**Addendum #1 to the Technical Drainage Study Update**  
**for**  
**Commercial Center (W. Deer Springs Way)**  
**DS5874**

**August 2025**

**Subject: Addendum #1 to the Technical Drainage Study Update for Commercial Center W. Deer Springs Way & N. Riley Street – DS5874  
(Previously Approved DS3031 aka Montecito Town Center)**

## Cross Section for Deer Springs Q100 = 145 cfs

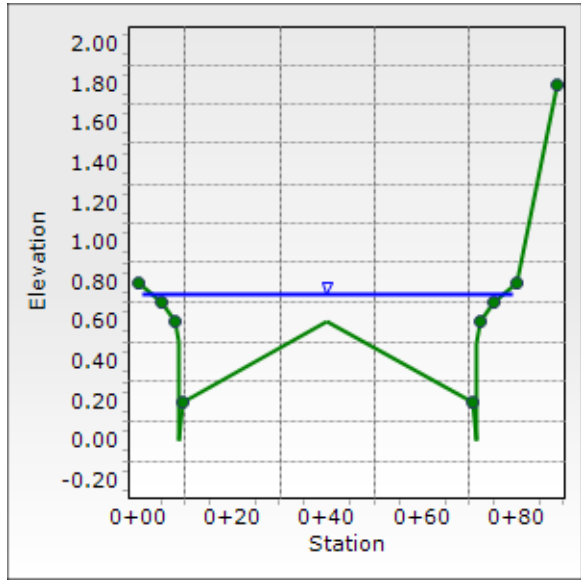
**Comment 1: From the reference Montecito Town Center Ultimate Drainage Condition Map, it looks like additional flow from basin ON3 will be added to Deer Springs Way. Address on the next submittal.**

Response 1: A revised FlowMaster model has been provided to use the flow value of 145 cfs which is represented as CP8 on the Montecito Town Center Ultimate Drainage Condition Map which takes into account runoff from basin ON3 entering Deer Springs Way and being conveyed via surface flow.

## Cross Section for Private Drive Min Slope 0.9%

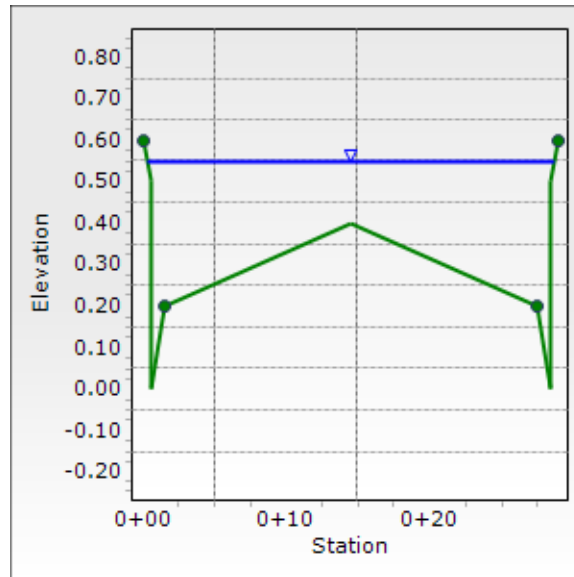
**Comment 2: What is the 100-year depth of flow in the private drive south of the proposed site. Provide a hydraulic cross section and calculations.**

Response 2: The depth of flow in the private drive south of the proposed site is 0.50'. The finished floor elevations are set greater than twice the depth of flow in the private drive.

**FIGURE 2-3**  
**MONTECITO TOWN CENTER**  
**ULTIMATE DRAINAGE CONDITION MAP**

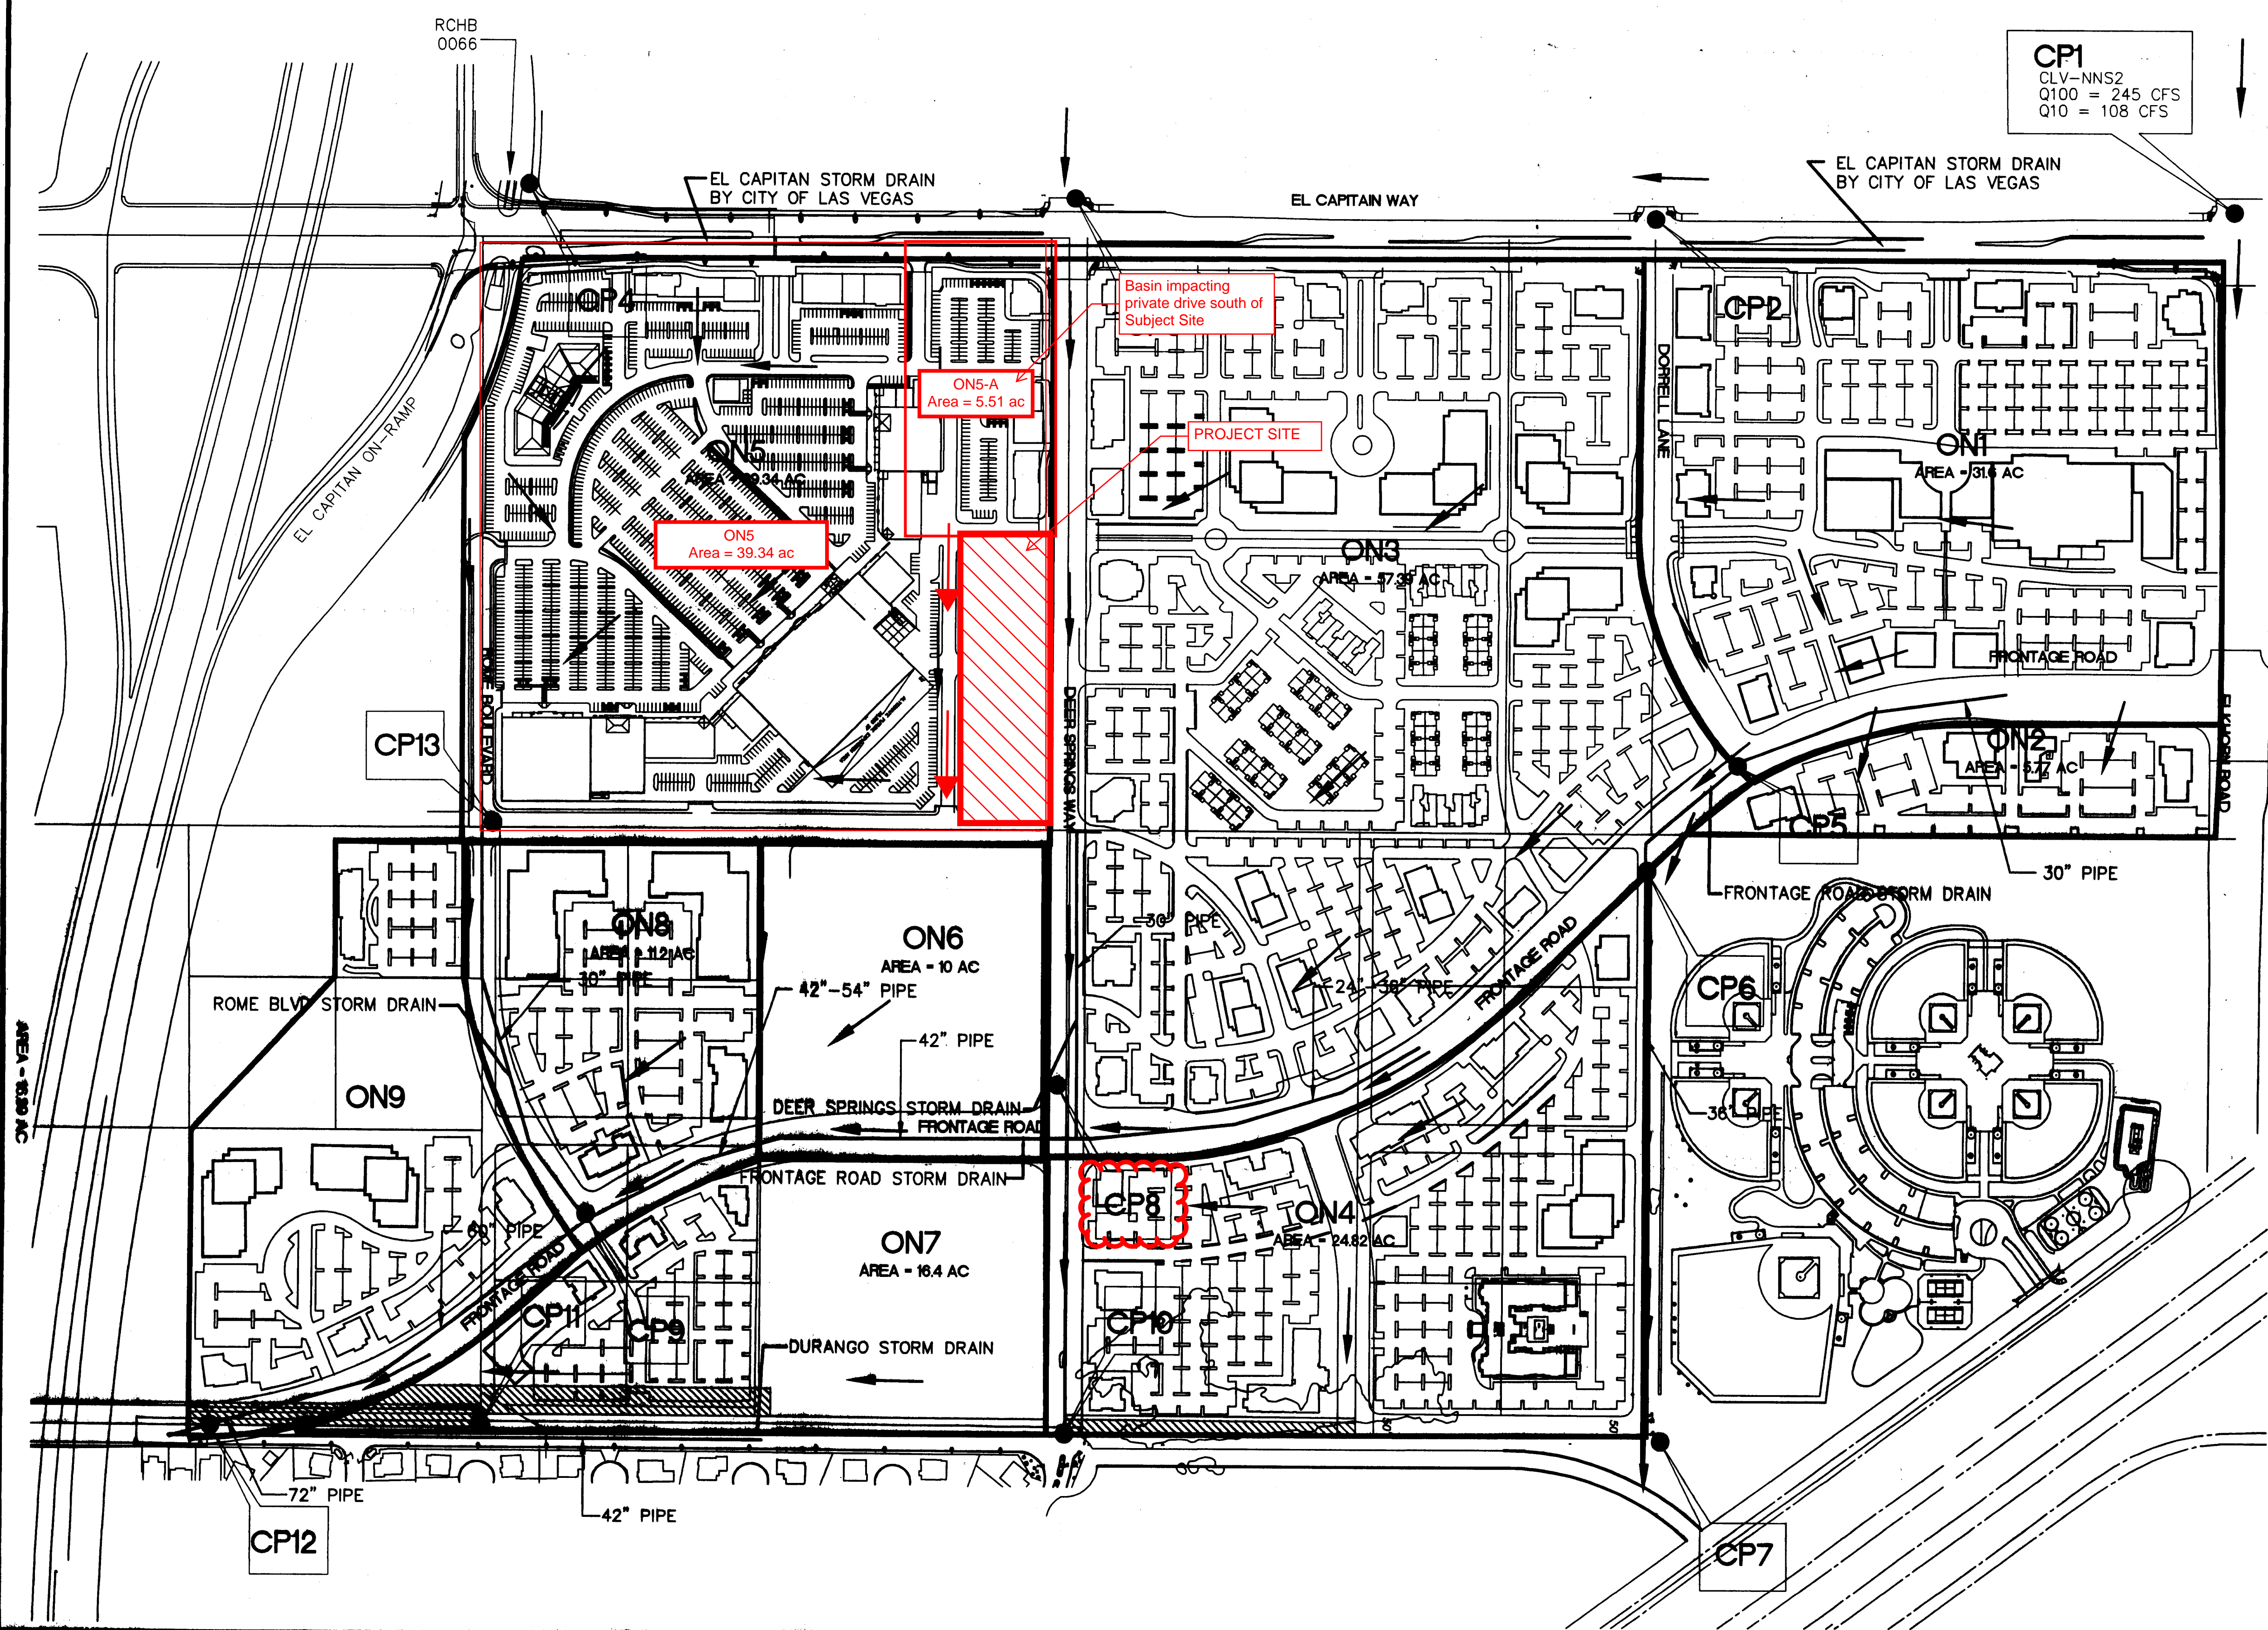
1. From the reference Montecito Town Center Ultimate Drainage Condition Map, it looks like additional flow from basin ON3 will be added to Deer Springs Way. Address on the next submittal.

used to calculate depth of flow in Deer Springs, adjacent to Subject Site
